TEXAS COMMISSION ON ENVIRONMENTAL QUALITY

Name of Project: **Central Texas Pain Center**; Located at 213 Hunter's Village; New Braunfels, Texas

Type of Plan: Request for Technical Clarification of an Approved **Water Pollution Abatement Plan**; 30 Texas Administrative Code (TAC) Chapter 213, Edwards Aquifer

Re: Response to TCEQ Comments dated June 23, 2014
Edwards Aquifer, Comal County
NAME OF PROJECT: Hunter's Creek Business Park, Lot 11B2; Located on the north side of Hunter's Village, approximately 150 feet northwest of the intersection of Hunter's Village and Oak Run Parkway; New Braunfels, Texas.
TYPE OF PLAN: Request for Approval of a Water Pollution Abatement Plan; 30 Texas Administrative Code (TAC) Chapter 213 Edwards Aquifer;
Additional ID No. 13-14052001; Investigation No. 1172139; RN107296733;

Figure 3-1 Schematic of Sand Bed Profile

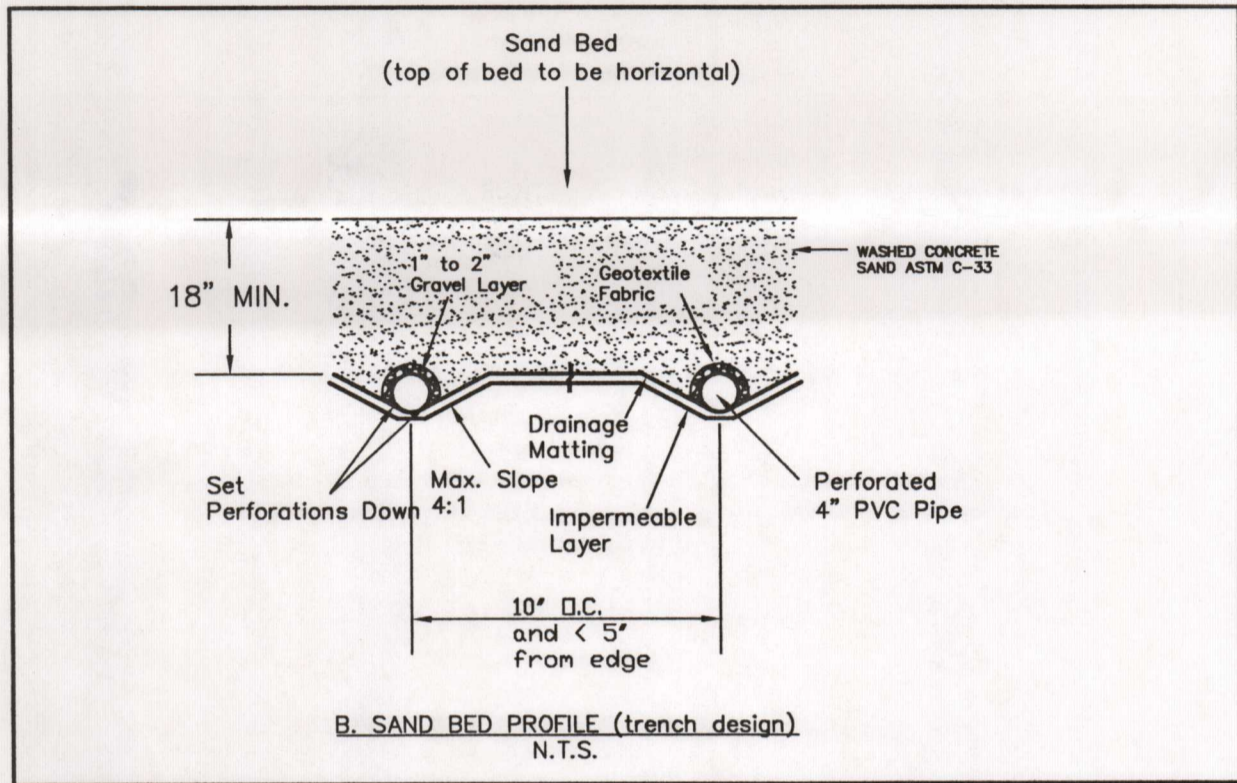
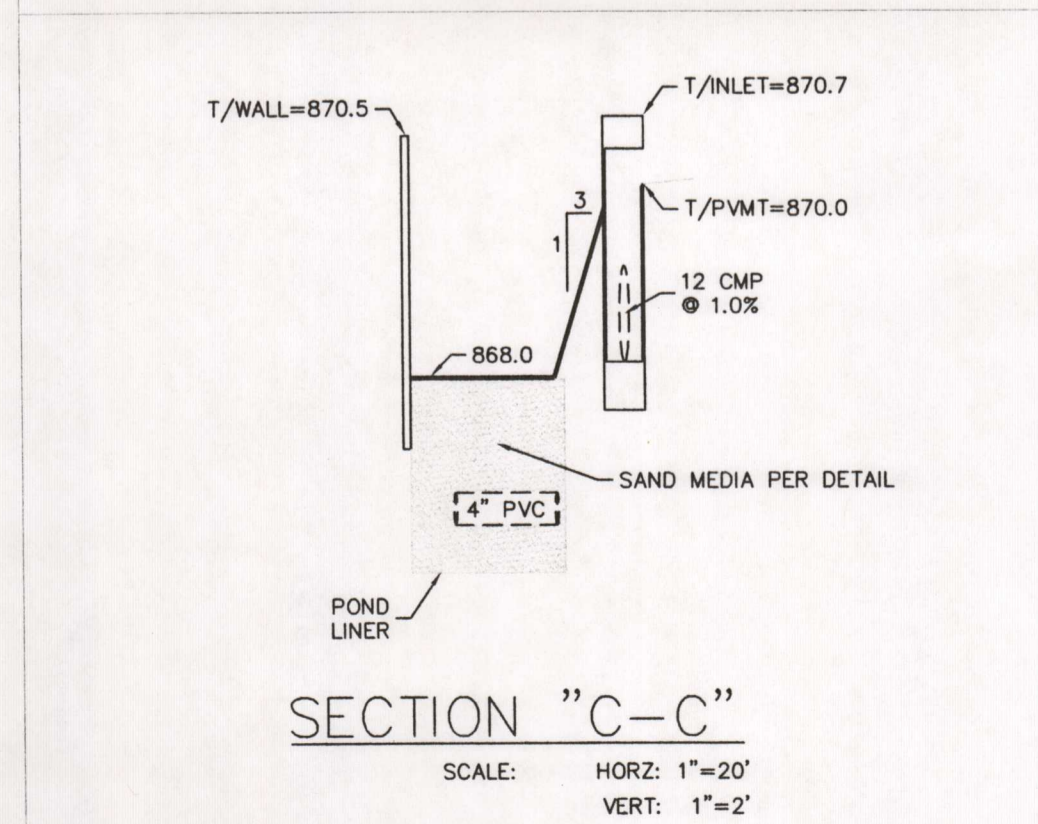
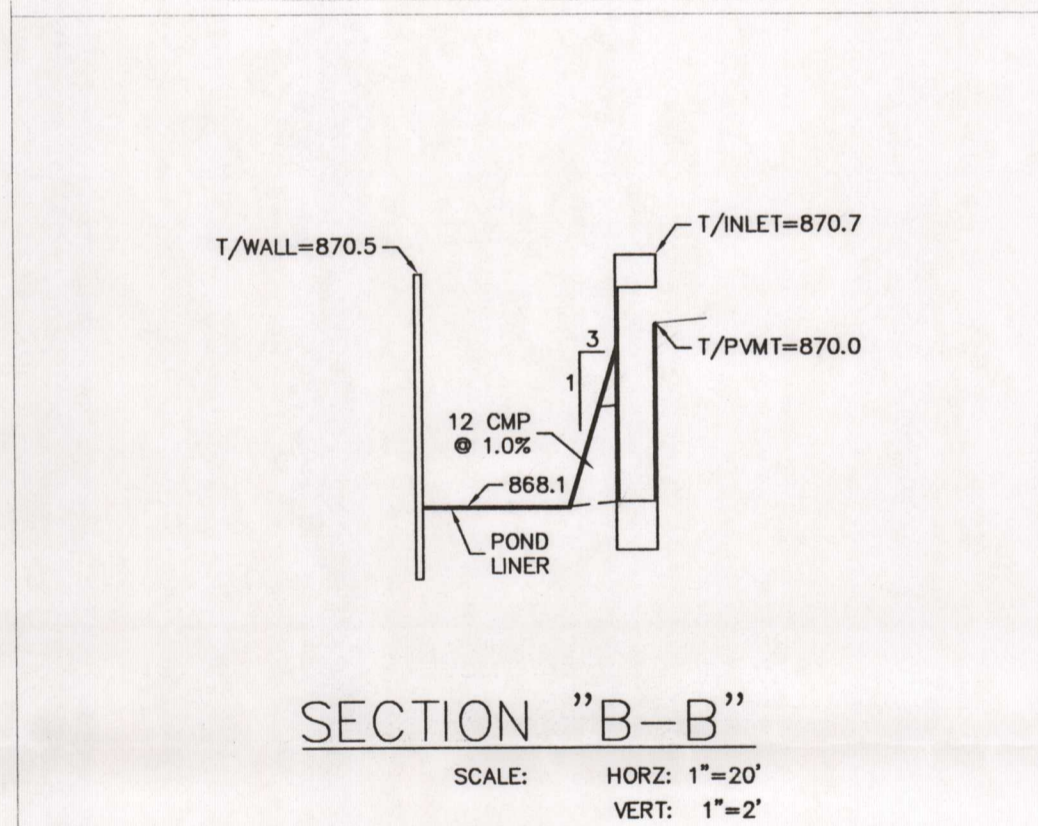
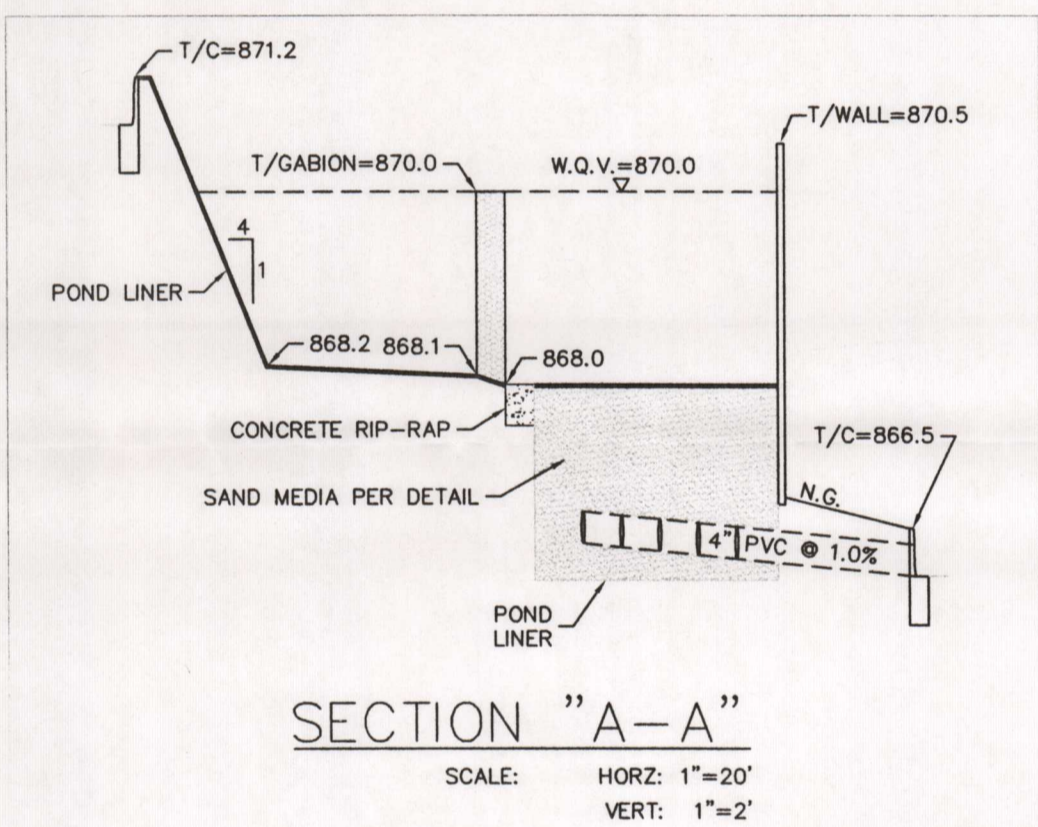
- On Sheet C5, in reference to the detail windows for the WQ basin, Sections A-A & C-C, the pond liner is shown on top of the filter media instead of the bottom. Please correct.

- On Sheet C5 two types of sand bed profiles are given. Choose one or provide elevations for both in order to confirm the WQV elevation. If both profiles are proposed as an option to the contractor then a special condition of approval will be added to have the engineer certify which sand bed profile was ultimately used for completion of the basin.
- Confirm the size of the area, in acres, of the two uncaptured areas in order to properly evaluate the calculations.

1. Enclosed is updated Sheet C5 to correct the detail for the sand bed profile.
2. The acreage of un-captured area in front of the bypass inlet is 0.0046 acres and the area of the driveway apron is 0.0054 acres. This is a total of 0.01 acres as shown as a deduction in what is going to the pond in the previously provided calculations.
3. In addition, the total water quality volume provided is 2,024 cubic feet as designed, compared to 1,949 as required by the calculations. The total sand filter area provided is 295 square feet as designed, compared to 162 as required.
